TECHNICAL BULLETIN
Bell Helicopter **TEXTRON**

No. 205B-03-21

MODEL AFFECTED: 205B

SUBJECT: LOWER NOSE DOORS P/N 212-030-217-011 & 212-030-205-001 AND SEAL REPLACEMENT

FIGURE 1 (SHEET 1 OF 4)
LOWER NOSE DOOR MODIFICATION

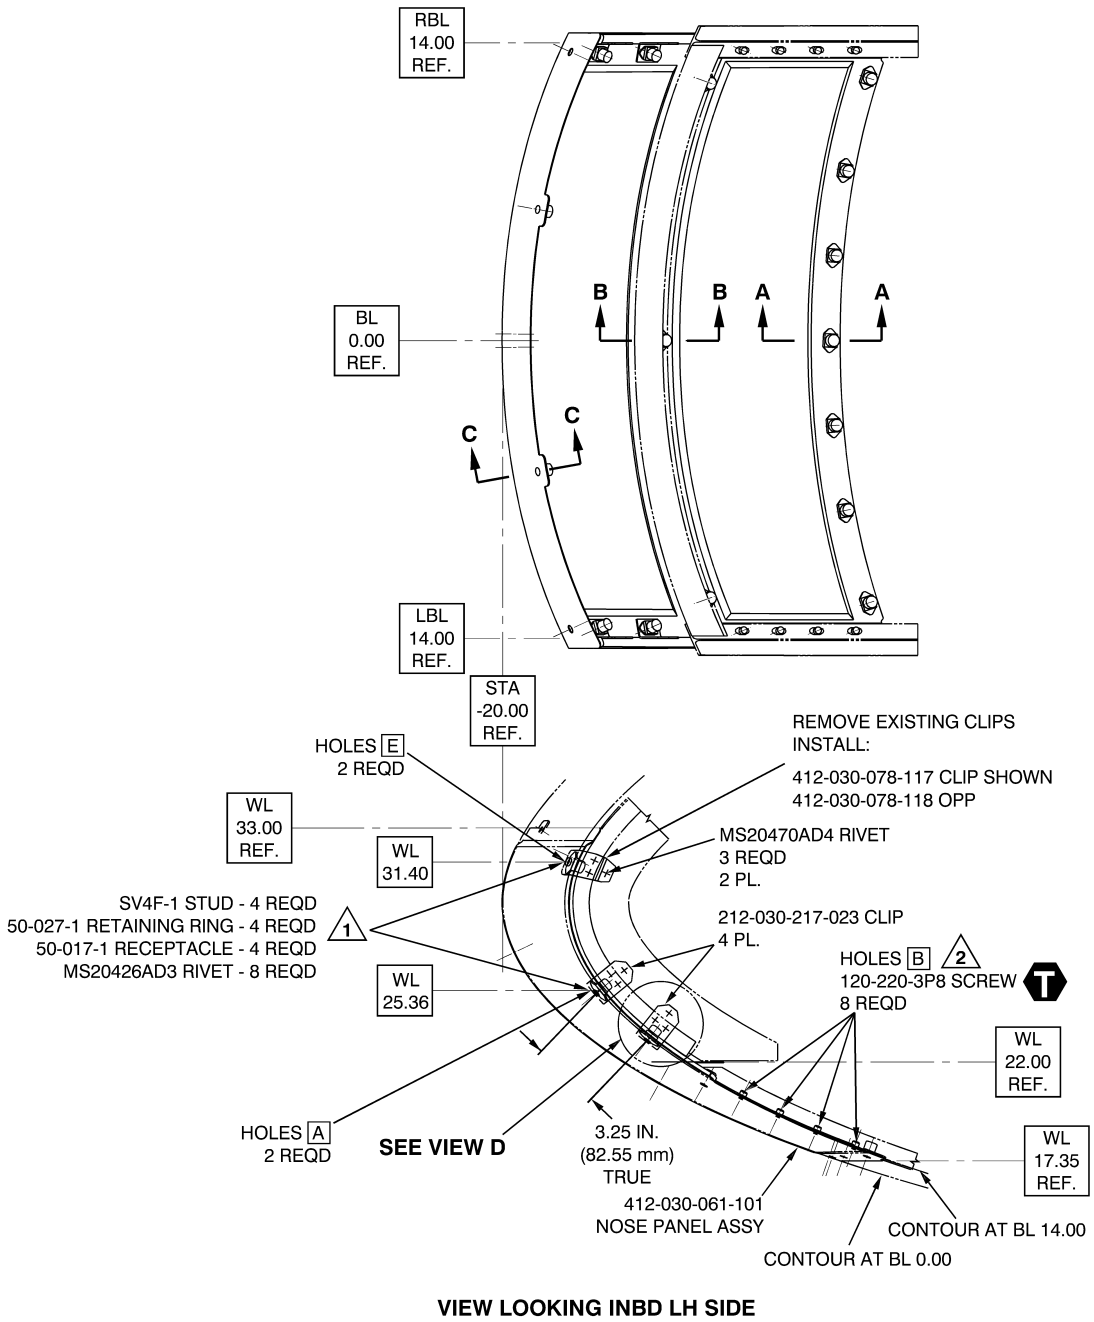
11. Position the new door P/N 412-030-061-101 and trim only enough to allow preliminary installation. **Do not trim to final dimensions at this time.**
12. Transfer holes A & B from structure. Reinstall previously retained receptacles and applicable hardware (see Figure 1, Sheet 1).
13. Using a locally fabricated template made from a sheet of clear plastic (or equivalent method), transfer holes C to nose door and install applicable hardware (see Figure 1, Sheet 2, Section B-B).
14. Position new clips P/N 212-030-217-023 inside nose door at approximately 3.25 inches (true) down from holes A, picking up existing rivet locations on frames at RBL and LBL 14 with a minimum edge distance of twice the rivet diameter. (See Figure 1, Sheet 1) Drill two pilot holes with a #40 approximately 1 inch from the edge to locate the center of the receptacle holes.

twice the rivet diameter. Install clips and open holes E to final size. Install previously retained receptacles and applicable hardware. (See Figure 1, Sheet 1)

FIGURE 1 (SHEET 2 OF 4)
LOWER NOSE DOOR MODIFICATION

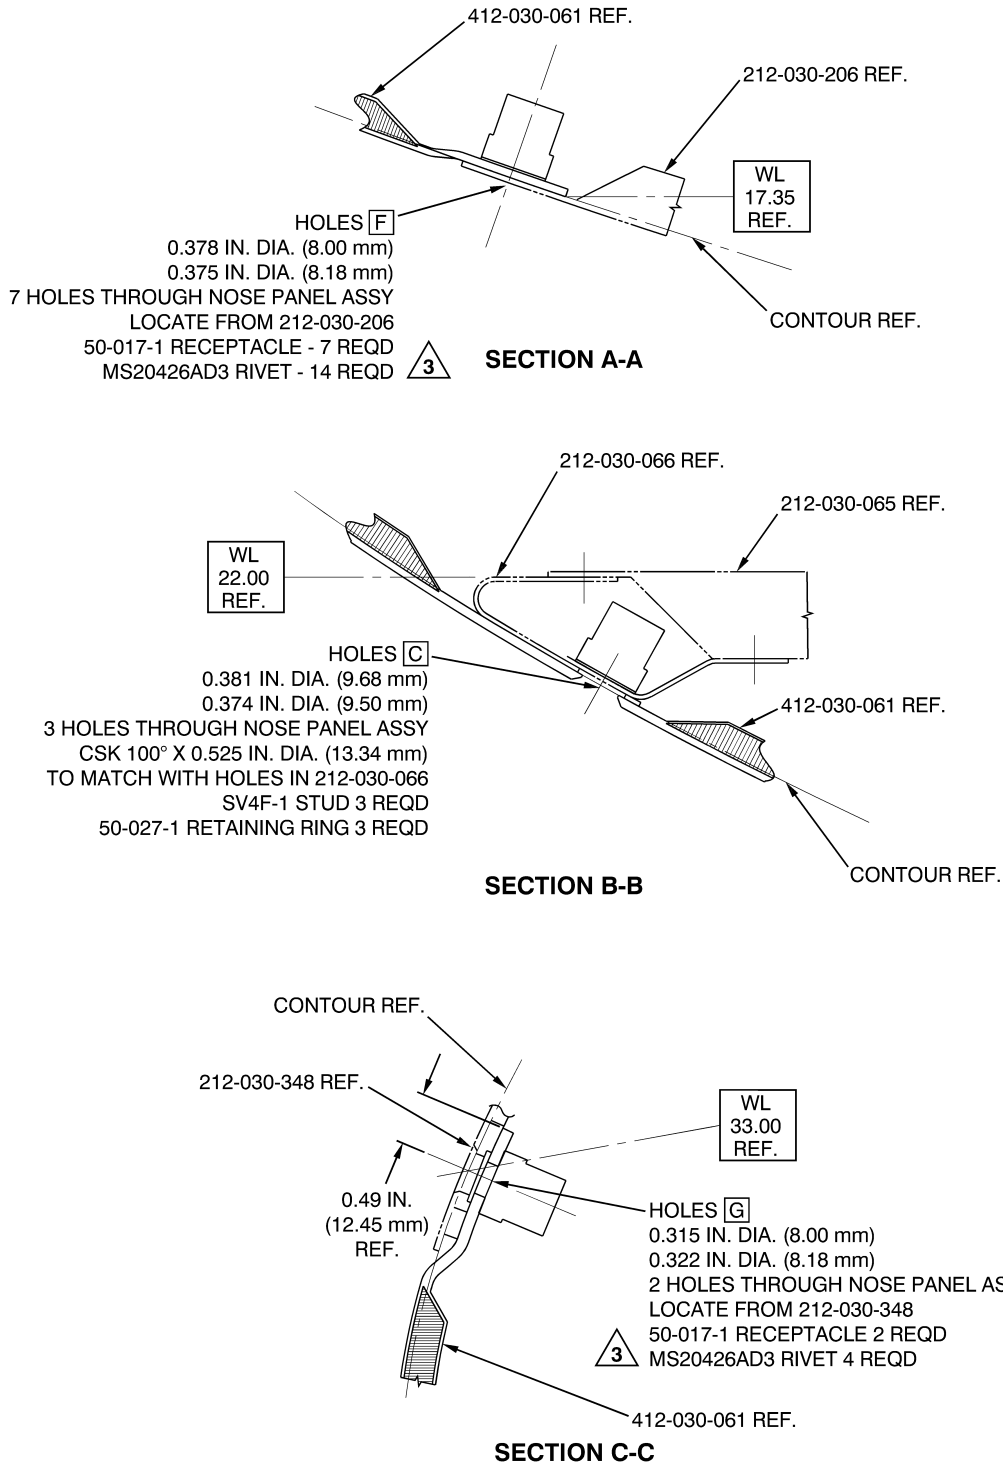
8. Remove the two clips P/N 212-030-217-025 (WL 31.40). Retain receptacles for reinstallation.
9. Remove receptacles from two clips P/N 212-030-217-023 (WL 25.36) and retain for reinstallation.
10. Remove (qty 7) studs from panel P/N 212-030-206-ALL (ref Figure 1, Sheet 2, Section A-A). Retain hardware for reinstallation.

17. Transfer holes F from panel (see Figure 1, Sheet 2, Section A-A) to the door assy. Open holes to final size and install applicable hardware.
18. Close upper nose door, transfer holes G, open holes to final dimension and install applicable hardware (see Figure 1, Sheet 2, Section C-C).

**FIGURE 1 (SHEET 3 OF 4)
LOWER NOSE DOOR MODIFICATION**

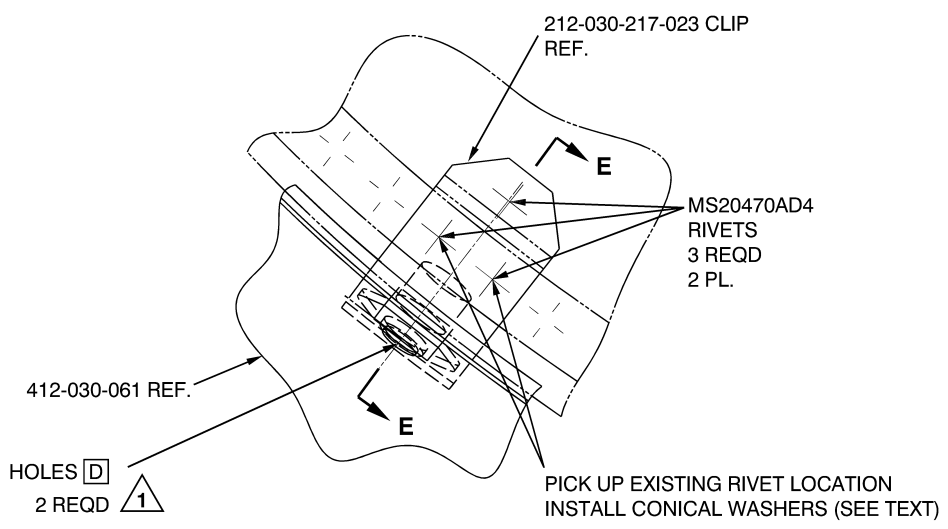
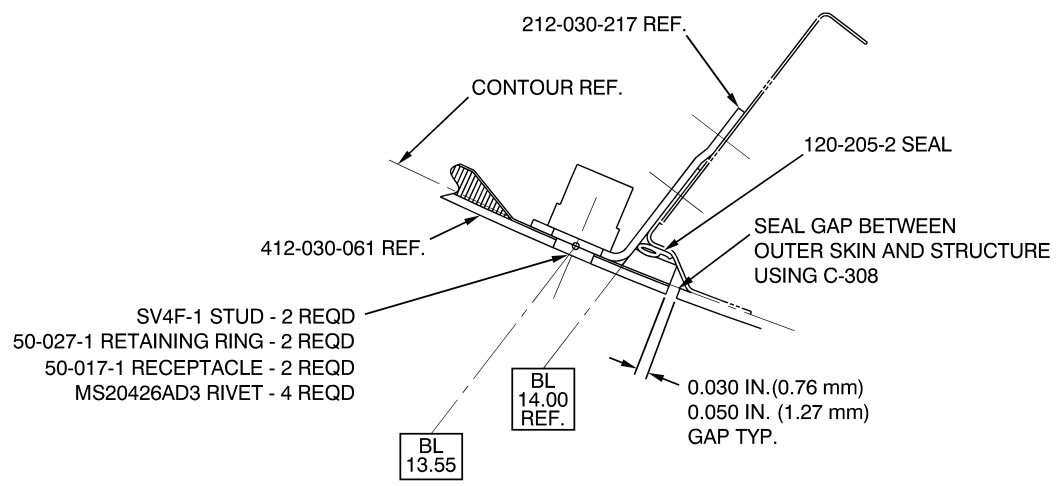
15. Install clips P/N 212-030-217-023 (see Figure 1, Sheet 3, View D), open holes D to final size and install applicable hardware.
16. Position clips P/N 412-030-078-117 and -118 to pick up the rivet holes left open by the previously removed clips at WL 31.4 with a minimum edge distance of

19. Once all fasteners are secured, mark for and trim the nose door to obtain a gap of 0.030 to 0.050-inch around the lower nose door. See Figure 1, Sheet 3, Section E-E.

3. Install seal P/N 120-205-2 on the nose structure around the upper and lower nose door opening using adhesive (C-300). Refer to Figure 1, Sheet 3.
4. Apply a light bead of sealant (C-308) around the nose door opening to seal the gap between the outer skin, the structure and the seal. Refer to Figure 1, Sheet 3. Allow sealant to cure for 24 hours.
5. Install upper nose door. Reinstall lower nose door (or refer to Part A, if replacing the door).
6. Close and latch nose doors, and verify for watertightness. Correct, if required.
7. Refinish as required.
8. Make helicopter ready for flight.
9. Make an entry in helicopter historical records indicating compliance with this technical bulletin.

FIGURE 2
SEAL INSTALLATION

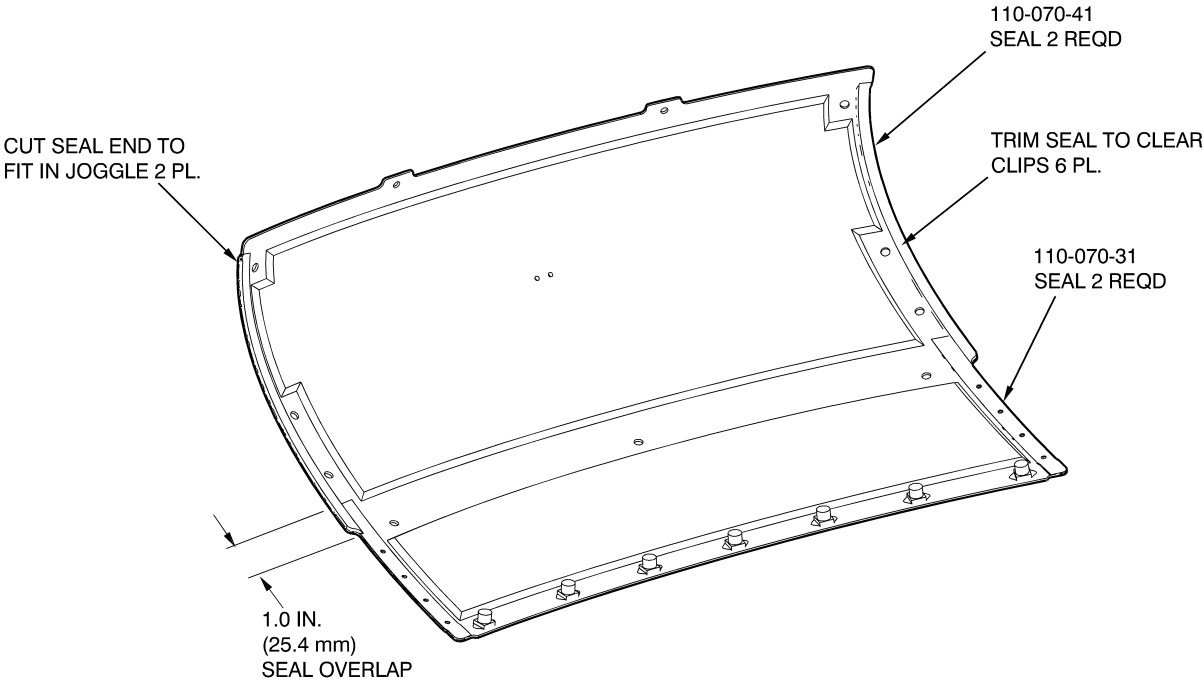
20. Install the door seals P/N 110-070-31 & 41 along left and right sides of the door, using adhesive (C-300), as shown on Figure 2. Trim seals to clear clips (6 places), if required.
